Keystone RV Company

1/22/24

SAFETY ADVISORY # 23-447

Coleman Axle Springs

Figure 1

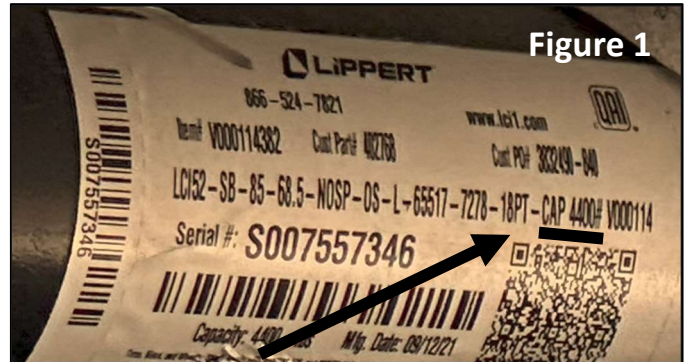
Inspect the axle tag, see Figure 1. If the tag reads CAP 5100#, no further action is needed. Proceed to warranty reimbursement for inspection only. If the axle tag reads CAP 4400#, proceed to Step 3.

The remedy is to replace under rated 4400LB springs with the correct size 5100LB springs.
